Advanced Medical Systems, Inc.

Re: USNRC Inspection Report No. 030-16055/95006 (DNMS)

**RESPONSE TO COMMENTS FROM
U. S. NUCLEAR REGULATORY COMMISSION**

**SEISMIC AND STRUCTURAL REVIEW OF ADVANCED MEDICAL SYSTEMS
LABORATORY FACILITIES**

Figure A-1. Masonry pilasters and steel columns.

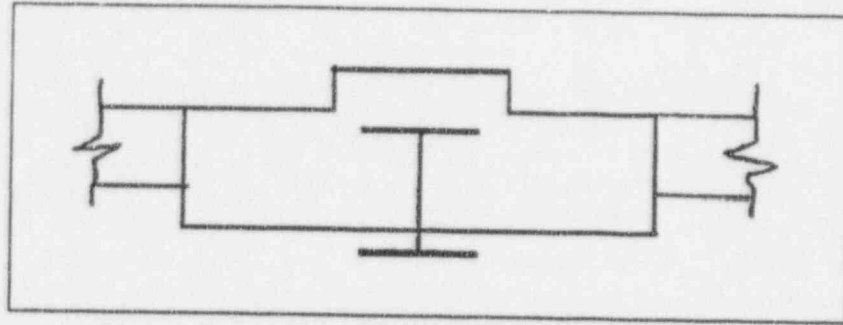
3.1 CONCERN-4/2/1: *The 1958 design, development and construction...encompassed the integration of a then existing warehouse/industrial building, with masonry load bearing walls and steel trusses as the roof framing steel...* This item was not a concern but a response is needed for clarification.

3.1 RESPONSE: The warehouse/industrial building referred to is not a complete load bearing masonry wall building with steel trusses, although at first glance it may appear to be. The building was constructed in 1934 as rectangular in shape. The east-west walls, the walls in the longer dimension (~100 ft), are non-load bearing masonry in-filled walls between steel-riveted columns that support the steel trusses. Some small amount of roof load between the trusses was originally carried by the east-west masonry wall, but this load was one-half of a purlin load, thus the wall typically would not be considered a load bearing wall. The tops of the east-west walls are basically unsupported in the out-of-plane direction except at the columns. At the columns, the masonry is placed flush with the column webs and a pilaster is built around the column flanges facing the original exterior of the building, with about six inches of brick covering the flanges. The sketch in Figure A-1 demonstrates the construction. Based on research done in the last 10 years (Henderson, et al., 1995), unreinforced masonry in-filled buildings provide excellent seismic resistance in low to moderate seismic zones. Although the 1935 building is not a true in-fill since the upper masonry walls are not confined by beams, the fact that they are in-filled within the floor and columns should provide lateral capacity of the building superior to a typical unreinforced load bearing wall. This is especially true where the old windows were filled in with masonry.

The north-south walls, the short dimension (~60 ft) of the building, are also constructed in the same fashion as the east-west walls. The only difference is the vertical columns at pilasters do not support any vertical load and the wall itself, between columns, supports one-half of the roof load that the trusses and columns support.

Figure A-2. Ceiling water damage.

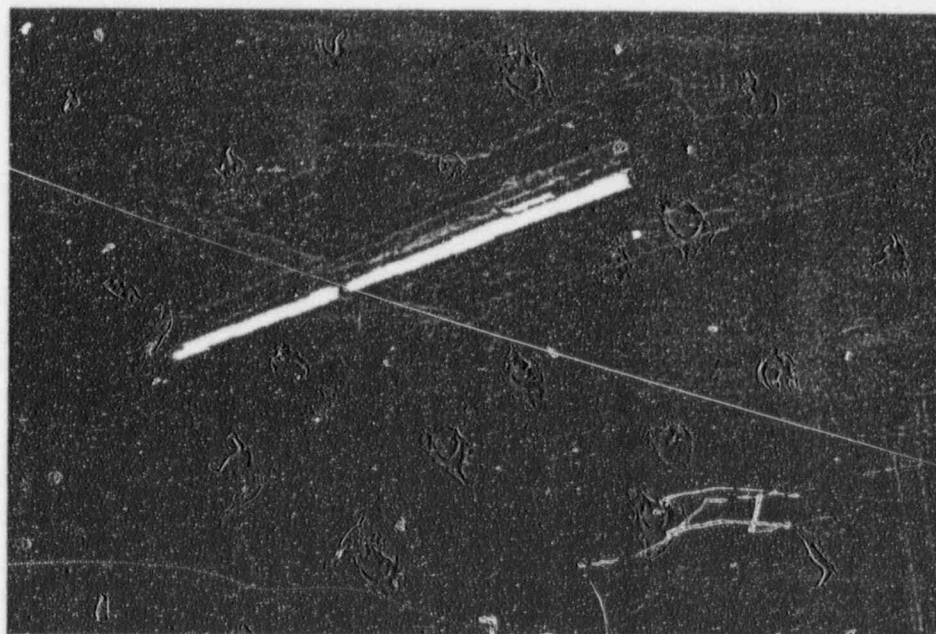
5.1 CONCERN-6/4/2: *In this area there is evidence of considerable amounts of water or other fluid apparently having penetrated on the second floor of the facility...*

5.1 RESPONSE: Two chases, one for electrical service conduit and one for ventilation, penetrate the second floor from the first floor into the equipment room on the second floor. The equipment room has a 10-inch riser around its perimeter, including the two doors, giving the impression that approximately 850 gallons of fluid would have to be spilled for a leak

outside the area to occur. This may have been the original intent; however, at both the conduit and ventilation chases, the risers are only two inches. In addition, at the ventilation chase, the riser has a 1½-inch notch in it. Thus, the maximum fluid that can be contained within the equipment is about 40 gallons. Therefore, the fluid runs over the ½-inch riser, down the chase onto the false ceiling. The first time a leak of significance occurred, the fluid collected in the false ceiling and was held there until the plaster of the false ceiling gave way as shown in Figure A-2.

This leakage caused no deterioration of the second floor slab's structural strength, and the fluids did not penetrate the concrete floor slab. There is no visible degradation of the floor slab, and it is highly unlikely there has been any degradation. In addition, the main part of the equipment room is over the radiography room where the floor slab is 2-feet thick.

Figure A-4. Cracked southeast corner wall.

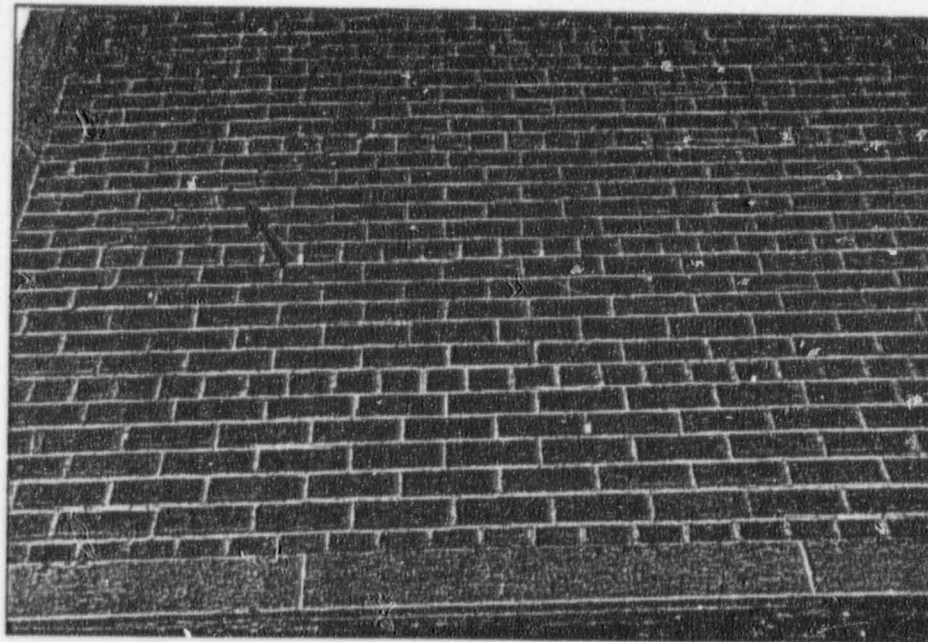
5.7 CONCERN-7/2/1: *The distress at the southeast corner of the building associated with the east 3-wythe load-bearing brick masonry wall...extending over approximately 4 feet vertically. The open crack, representing ... in the once continuous load bearing masonry wall that is 12 and 1/2-inches thick (Dwgs A-10 and P-2).*

5.7 RESPONSE: As described in the NRC report, cracking does exist and is shown in Figure A-4. From the outside, the cracking appears to stop just short of the area where the second floor slab ties into the common wall brick. From inside the building below the second floor, it is evident that cracking does extend through the wall; however, it is not continuous, i.e., the cracking on the inside of the wall is almost an opposite pattern, as shown in Figure A-5.

Figure A-7. Wall movement at purlin in corner.

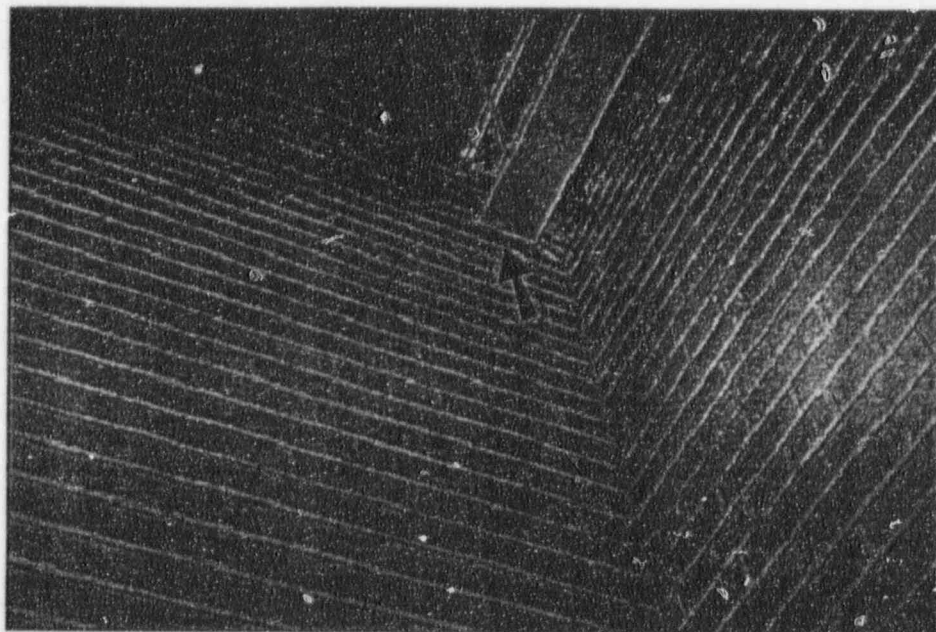
- 5.13 CONCERN-7/4/12: *On the inside of the 1958 building at this purlin bearing there is evidence of movement between the bearing wall and the purlin in the longitudinal direction...is not known...which structural element remains with the permanent movement...*

- 5.13 RESPONSE: This movement appears to be approximately 1/4-inch as shown in Figure A-7. Although such movement may occur for a building having a mix of materials involving steel, concrete, and masonry as main structural elements, this movement must be attributed to the corner moving to the southeast at the second floor. According to Dwg. S-1, all beams bearing on the masonry wall have wall anchors. These anchors are two angles, 6 inches by 4 inches by 3/8 inch. Thus, the wall anchor should be holding the common masonry wall from moving further eastward at the top. No sign of distress in the veneer

wall was noted from the outside, however, some cracking was noted in the load bearing wall beneath the purlin.

Figure A-8. Purlin and Wall Movement.

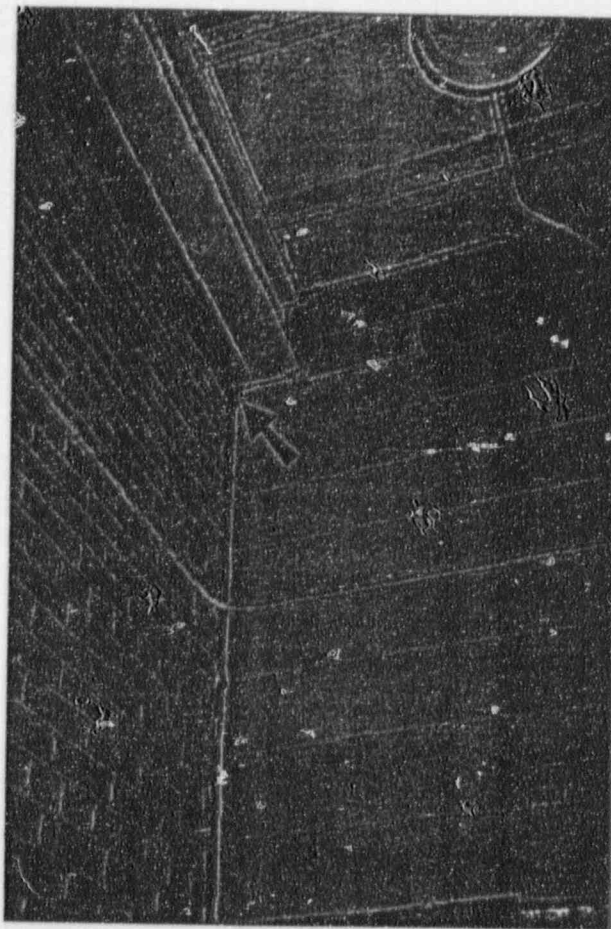
5.15 CONCERN-8/2/1: *The distress of the east wall near the northeast corner of the 1958 building is associated with a rupture type failure...rupture line is most pronounced in a verti-*

cal direction just adjacent to the northeast steel column... rupture surface is generally through every other course of concrete block and does not follow a saw tooth pattern...

5.15 RESPONSE: Paragraph two on Page 8 of the NRC report is mostly about the cracking of the in-filled wall. Upon inspection of this wall's cracking and movement, it seems quite evident what is occurring. Basically, it is a problem of the second floor in-filled wall moving outward over the lobby area between the steel columns at Column Lines D and F. This movement can clearly be seen from the roof and is causing rotational stresses to be placed on the original corner of the 1958 building as the east-west wall tries to keep the east wall from moving outward. The fact that the 1958 building in-filled wall was placed tightly against the inner side of the outside column flange, and the fact that ties attached the two wythes of facing brick to the 1958 building concrete block, the 1958 building in-filled wall is being pulled outward next to Column F-1, failing the in-filled wall in shear at the edge of the flange. Without further inspection, and possibly some destructive inspection, it is difficult to determine the specific cause. Fricke, et al. 1978 have addressed such problems and found that temperature and moisture effects combined with constrained

expansion can result in this type of behavior in such construction. This is not a structural issue, but it is a life-safety issue.

Figure A-9. Lobby stone showing salting.

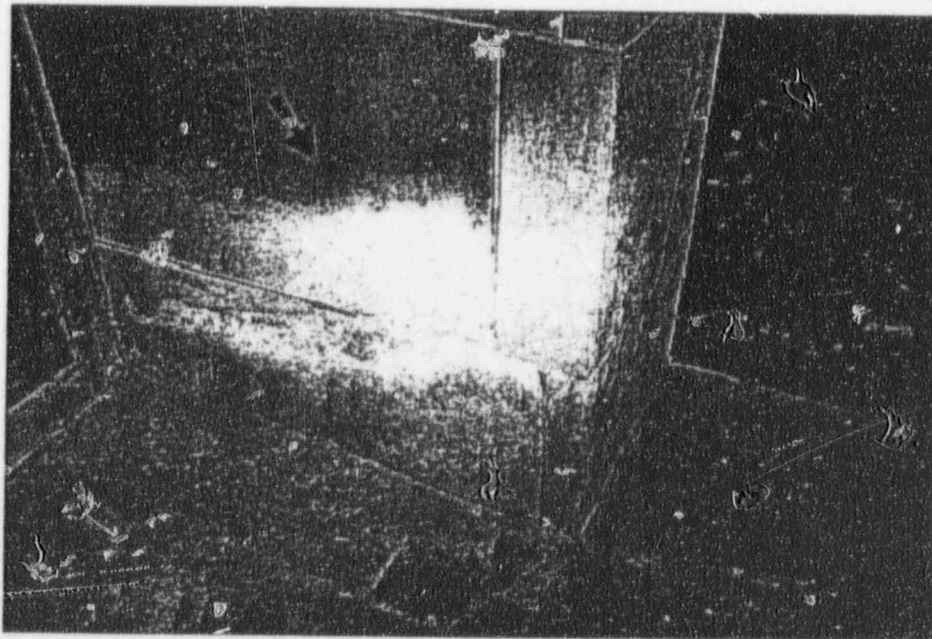
5.16 CONCERN-8/2/17: *In addition, the stone corner and stone return at the northeast corner of the 1958 building show displacement and rotation at the corner with failed joints.*

5.16 RESPONSE: It is believed that the failure of the stone corner at the bottom of the wall has resulted from a totally different cause, but may have something to do with the in-filled wall movement at the second floor. This stone corner is located next to the lobby entrance of the 1958 building. Upon inspection of the site, it is very apparent that the joint failure of the mortar has been caused by salting the lobby entrance to remove snow and ice. The stone facing is discolored where the salt was thrown as shown in Figure A-9, and where discoloration has occurred, mortar in the joint was attacked. At a distance of approximately one foot north of the south corner of the stone, there is no stone discoloration and the joint is intact. As a result of joint failure, the stone has fractured. Again this is a life-safety issue and has no bearing on the structural stability of the 1958 building.

Figure A-10. 1963 building parapet.

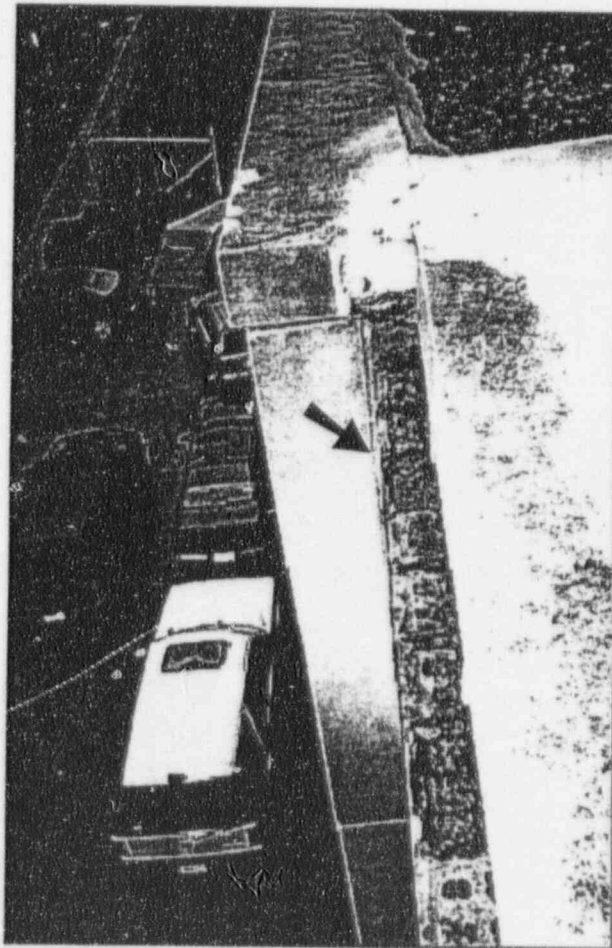
5.17 CONCERN-8/2/18: *The distress was also reflected in the displacement of the stone coping at the top of the walls as they intersect at the northeast corner of the building...*

5.17 RESPONSE: While there is significant distortion of the stone coping on the parapet of the 1963 building as shown in Figure A-10, with the 1958 building parapet being in the background, this distortion is not believed to be associated with Concerns 5.15 or 5.16 discussed above. Rather, it is believed to have been caused possibly by a crane or crane-like piece of equipment placing workers or equipment on the roof. The movements of the stone coping of the 1963 building do not relate to the movements that have occurred at the northeast corner of the 1958 building.
